## Service Bulletin RU\_SB037

**Author:** Alexander Gaiderov, Technical Support  
**Date:** 2004-03-23  
**Subject:** GSM Triplets – Keypad Activation with Flip Closed  
**Rating:** Level 2 Authorized

**Products:** V300, V400, V500, V525, V600

Diagram 1.0(a) – Good Sleep Mode Current

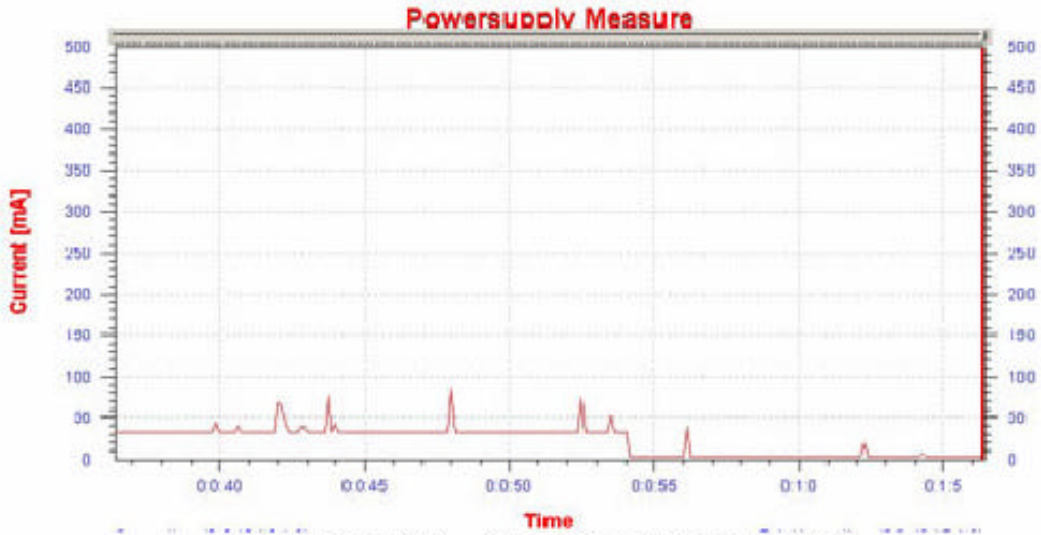
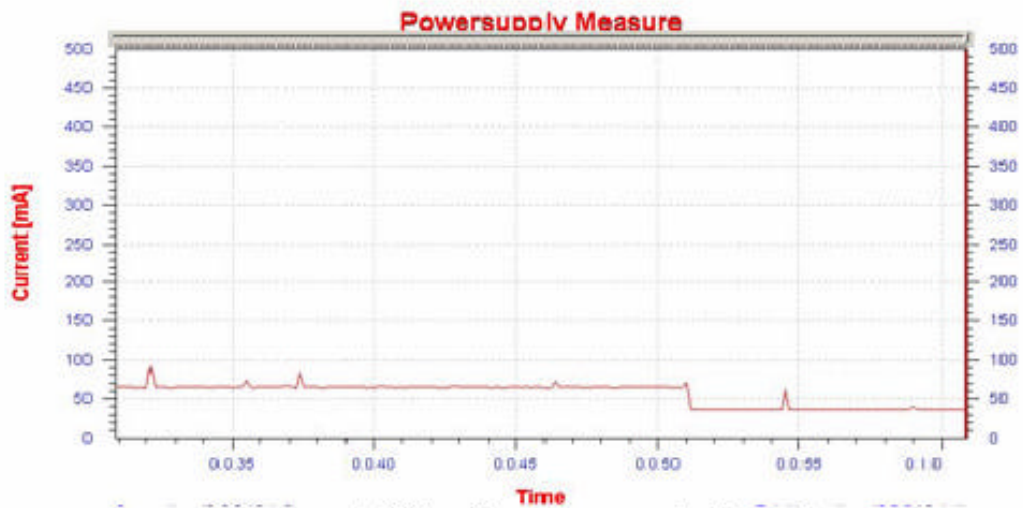
b. Close the flip and apply a slight pressure to the area directly below the CLI Display, using your thumb, to simulating the use of a holster.  
c. Allow the unit to enter sleepmode while measuring the current. The sleepmode current should read less then 1mA on a good unit and will read approximately 30mA on a failure. See diagram 1.0(a) and 1.0(b) below for

comparison of “Good” versus “Bad” current measurements.

Diagram 3.0 – Keypad Vendor Identification

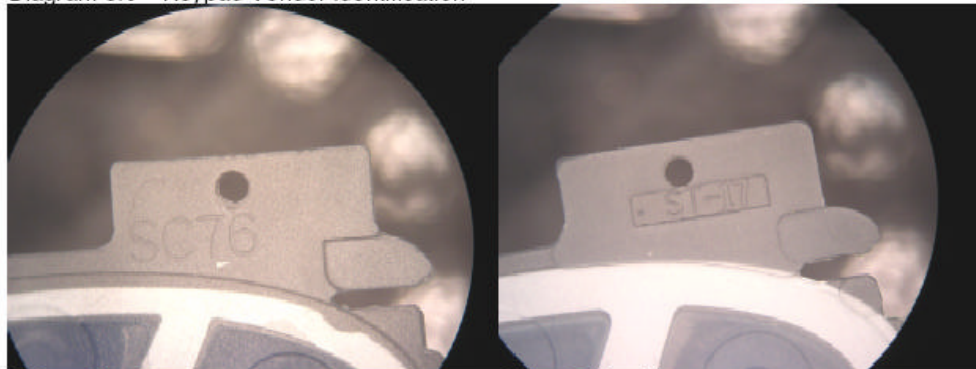
1. Verify if the units were built with Shin-Etsu keypads. See diagram 3.0 below.
2. Replace the keypad, using a Sinco Keypad if possible, and retest.

SC = Sinco

ST = Shin-Etsu
